**Subject:** RE: AUG-33-Willipie Interchange EB Loop Ramp Truck parking, PID 122890 Utility Verification - Fiber Optic Line conflict with proposed Strom Pipe

**RE: AUG-33-Willipie Interchange EB Loop Ramp Truck Parking, PID 122890 Utility Verification**

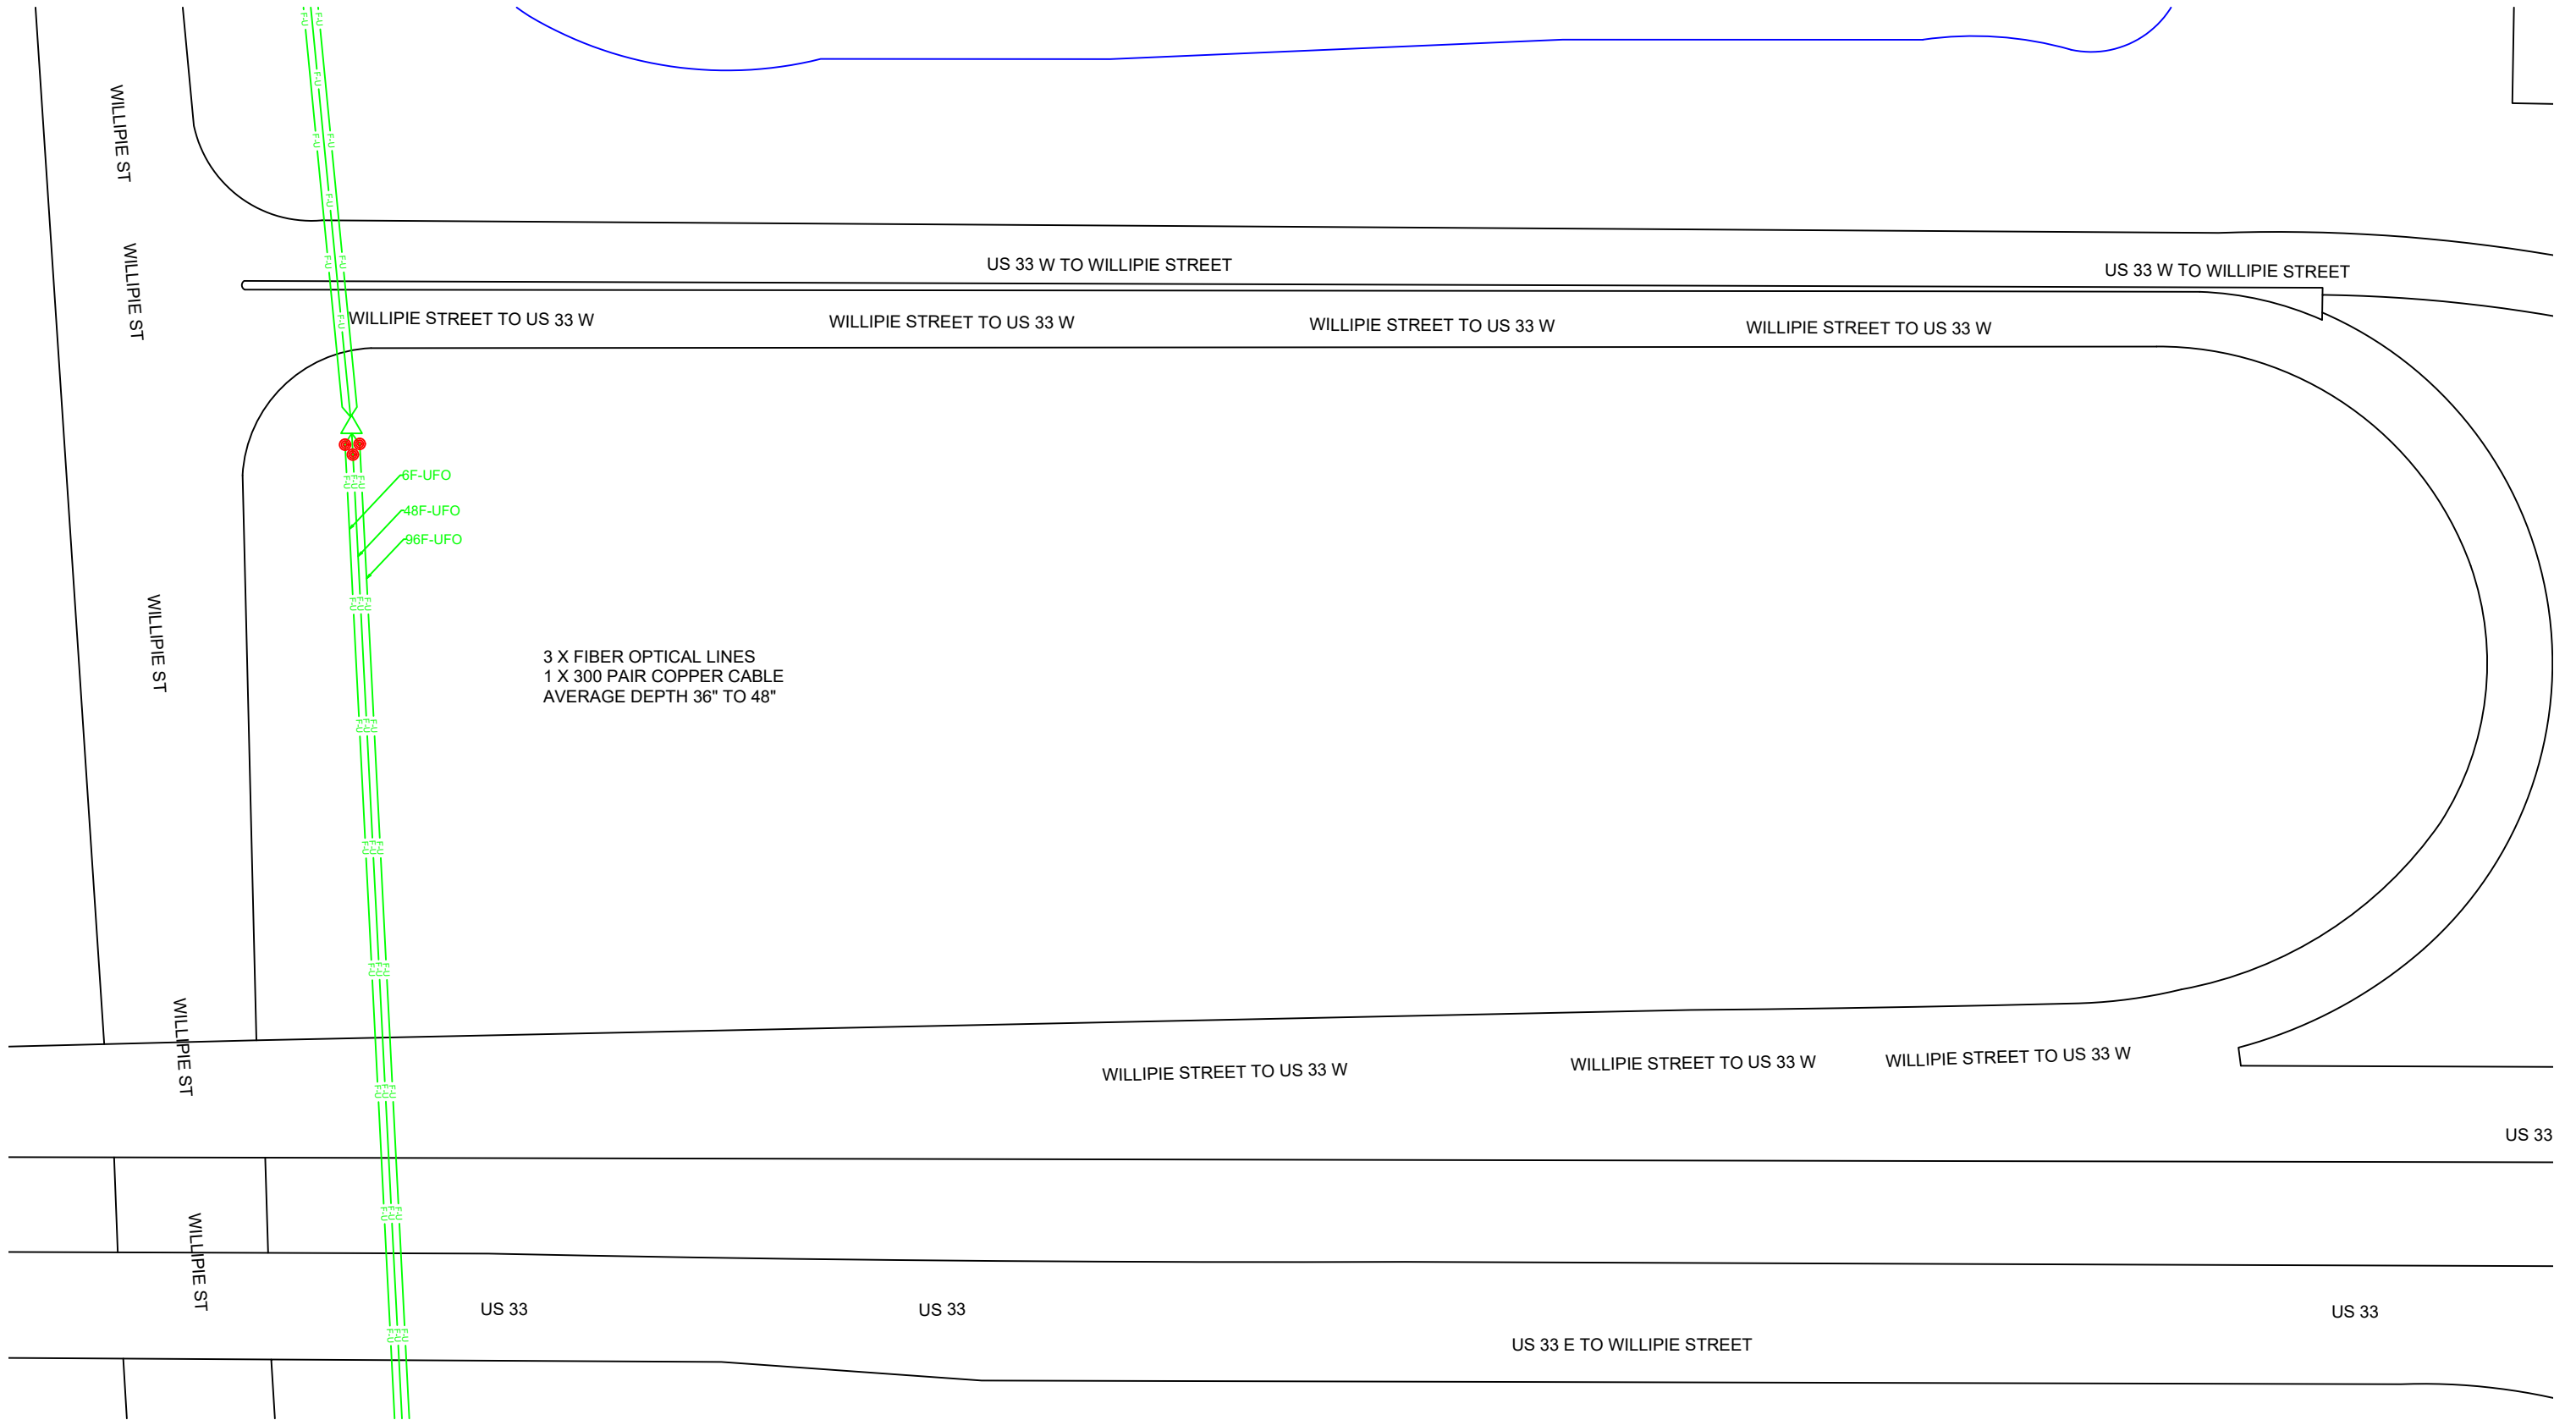
Chris, I do have one clarification question. Please review the attached PDF and confirm the proposed routing of the overhead line. Will the line be installed between Pole 1 and Pole 2, or are you planning to utilize Pole #3 as shown in the PDF?

Afternoon – We checked our facilities in the area where the 24” storm pipe is going to cross. Currently it is 4’ 2” at this crossing. We are working on a solution for this issue. Our tentative plans are to move to aerial.(highlighted in green below) Is there going to be a conflict with this solution?

Pole # 3  
Are you planning to  
use this pole to  
attach your facility.

If yes this pole will be  
relocated by the City.  
Need coordination  
with the City

ODOT has not objection with overhead relocation, as long as the pole owners permit it and there is adequate clearance for trucks.

Chris – I do not have any concerns with routing your facility overhead, provided the work is coordinated with the pole owners and ODOT District 7 approves the utility permit.
